ANADROMOUS WATERS CATALOG/ATLAS CORRECTION FORM

REGION: SOUTH CENTRAL

MAP: (50) BLYING SOUND D-1 D-2

WATERWAY NUMBER: 227-30-17790-2018-3051

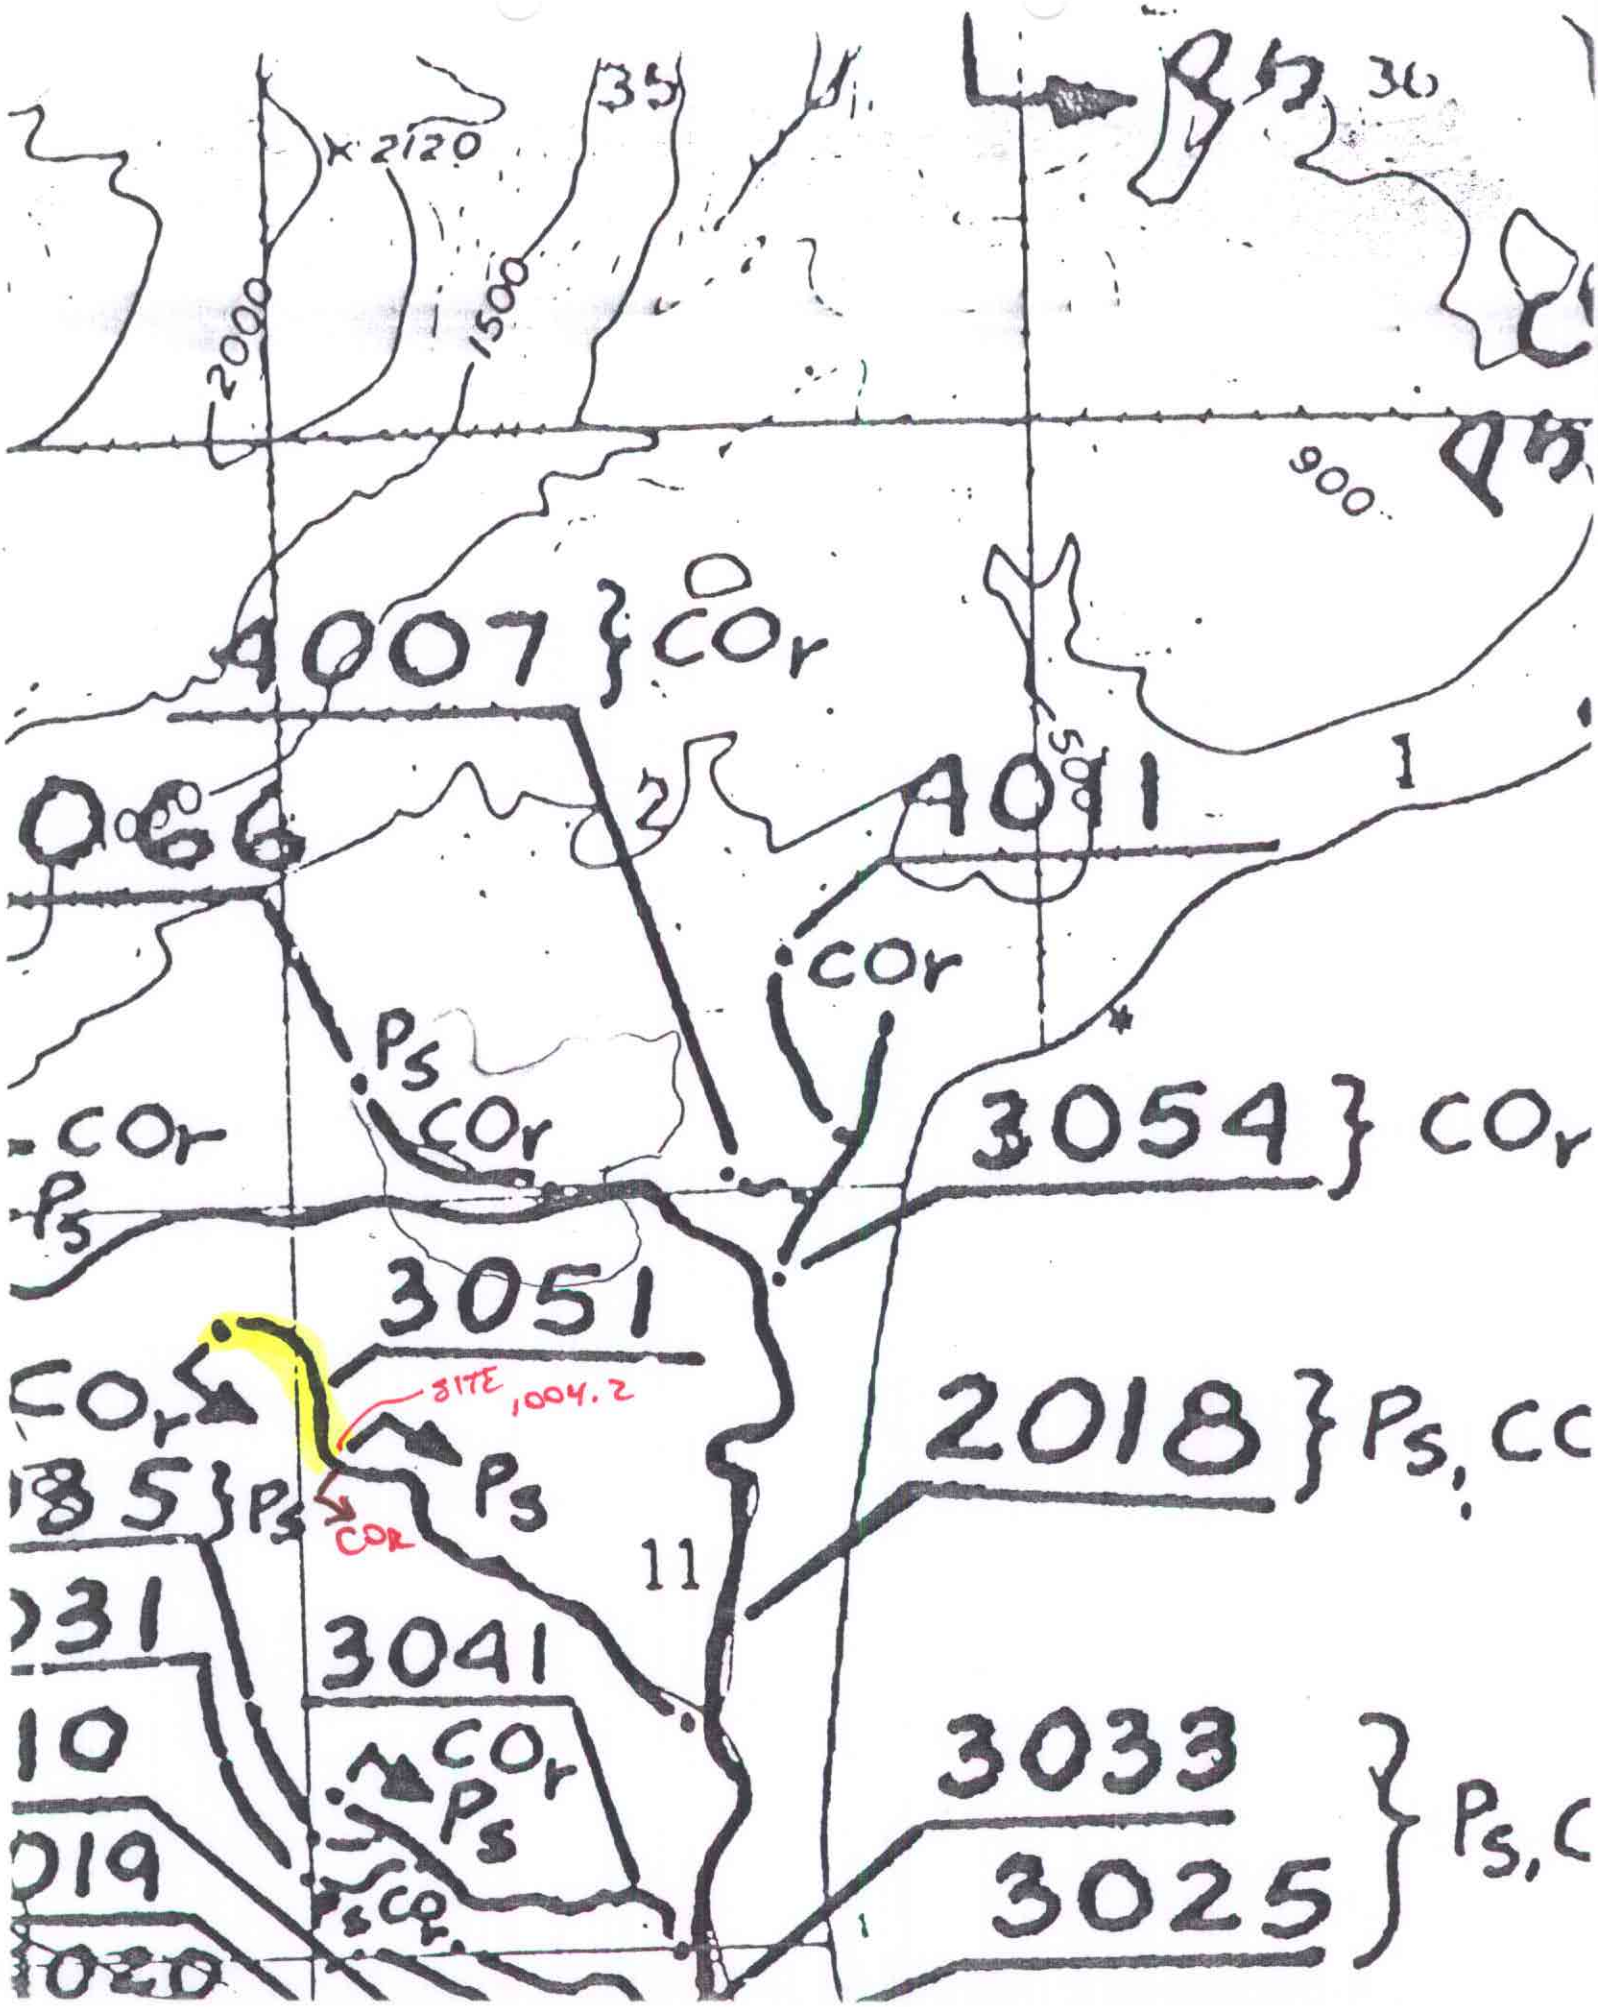
DESCRIBE CHANGE(S): DELETE UPPER PORTION OF STREAM AS NOTED ON ATTACHED MAP. UPPER PORTION OF STREAM WAS INAPPROPRIATELY ADDED BASED ON HABITAT ONLY. UPPER KNOWN LIMIT OF COHO REARING IS @ SITE 1004.2
